HISTORIC AND DESIGN REVIEW COMMISSION

February 07, 2024

HDRC CASE NO: 2024-030
ADDRESS: 1210 E ELMIRA ST
LEGAL DESCRIPTION: NCB 6796 BLK 8 LOT 1 THRU 3 & S IRR 124.65 OF 4-6 & S IRR 42.09 FT OF 7
ZONING: IDZ, RIO-2
CITY COUNCIL DIST.: 1
APPLICANT: Daniel Elder/Oxbow Real Estate, LLC
OWNER: Daniel Elder/Oxbow Real Estate, LLC
TYPE OF WORK: Construction of a pedestrian bridge across the San Antonio River
APPLICATION RECEIVED: January 19, 2024
60-DAY REVIEW: April 7, 2024
CASE MANAGER: Edward Hall

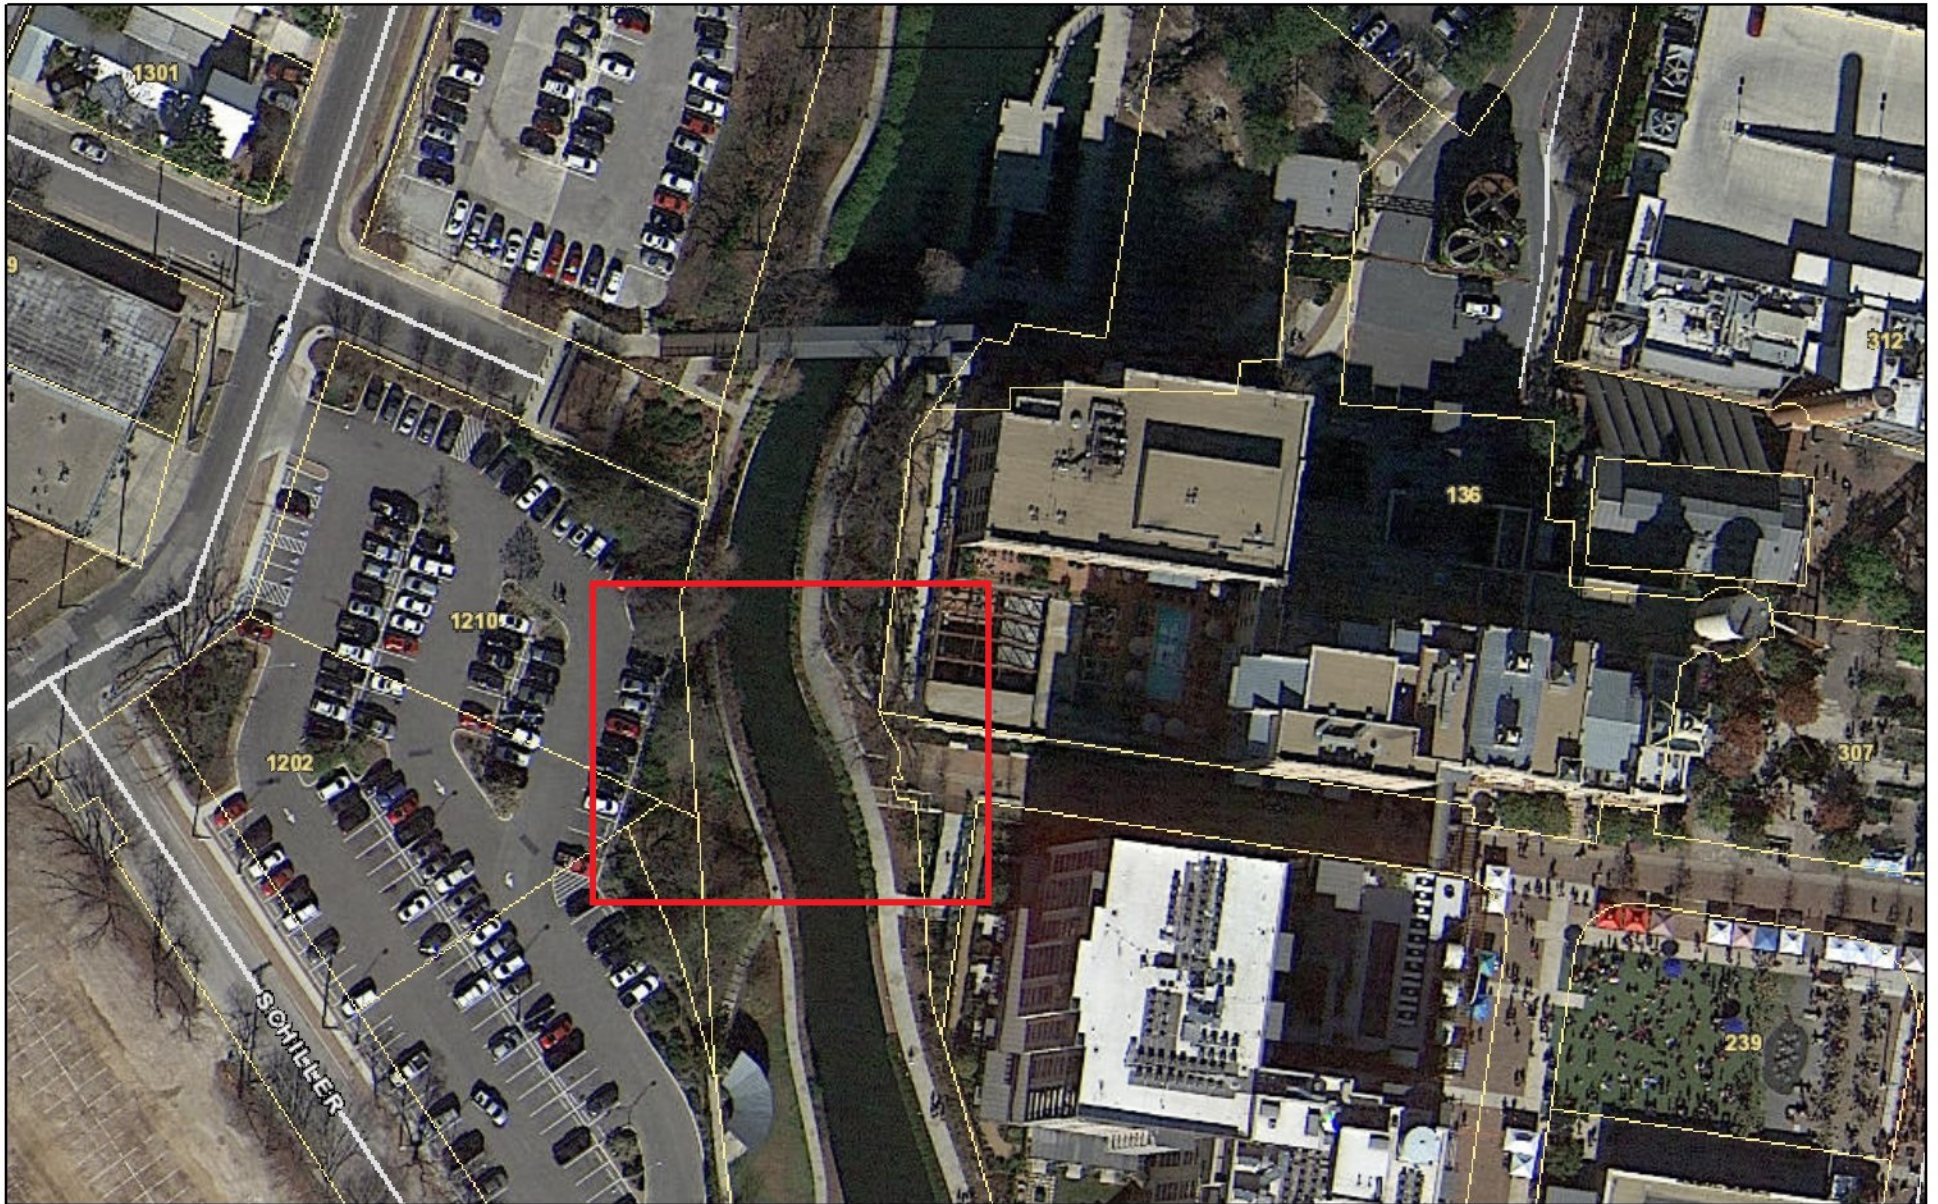
- d. **PEDESTRIAN BRIDGE** – The applicant has proposed for the bridge to feature an overall span of approximately 105 feet, with clearances above the pedestrian path at the Riverwalk of 8' – 6" on the west side and 13' – 2" on the east side. Staff finds this to be appropriate.
